Access Compliance Report

Public Rights-of-Way

Intersection ID: 9469	Main Street: BUNGALOW_RD	Cross Street: CLYDE_DR	Location: W
ADA ID: F5950671C2C8	Ramp Type: PerpDiag	Initial Pass/Fail: Fail	Overall Compliance: No
		Severity Score: 35

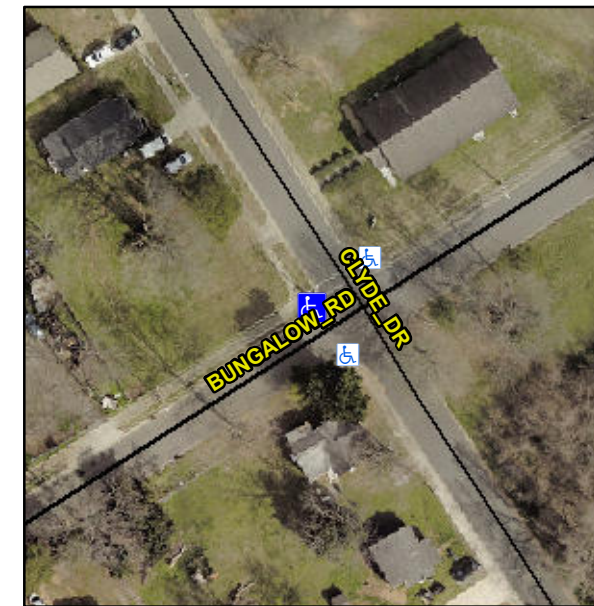
Not Found, R304.5.1

Compliance	Description	Data	Compliance	Description	Data
N/A	Ramp Length (in)	81.0	Yes	Ramp Slope (%)	5.5
No	Ramp Width (in)	30.0	Yes	Ramp XSlope (%)	1.5
N/A	Flare Type LT	N/A	N/A	Flare Type RT	N/A
N/A	Flare Slope LT (%)	N/A	N/A	Flare Slope RT (%)	N/A
N/A	Flare Traversable LT?	N/A	N/A	Flare Traversable RT?	N/A
N/A	Landing Length (in)	N/A	N/A	DWS Provided?	N/A
N/A	Landing Width (in)	N/A	N/A	DWS Contrast?	N/A
N/A	Landing Slope (%)	N/A	N/A	DWS Length (in)	N/A
N/A	Landing X Slope (%)	N/A	N/A	DWS Full Width?	N/A
N/A	Landing Curb? (Y/N)	N/A	N/A	DWS Offset (in)	N/A
N/A	Shared Landing?	N/A			
N/A	Gutter Ponding?	N/A	N/A	Gutter Slope (%)	N/A
N/A	Gutter Lip Ht (in)	N/A	N/A	Gutter X Slope (%)	N/A
N/A	Painted X Walk1?	No	N/A	Painted X Walk2?	No
	X Walk 1 Direction	To SE		X Walk 2 Direction	To NE
N/A	X Walk 1 Width (in)	N/A	N/A	X Walk 2 Width (in)	N/A
	X Walk 1 Slope (%)	0.6		X Walk 2 Slope (%)	1.9
	X Walk 1 X Slope (%)	1.9		X Walk 2 X Slope (%)	0.9

Possible Solutions:

Remove & Replace Curb Ramp With Two New Directional Ramps or Equivalent.
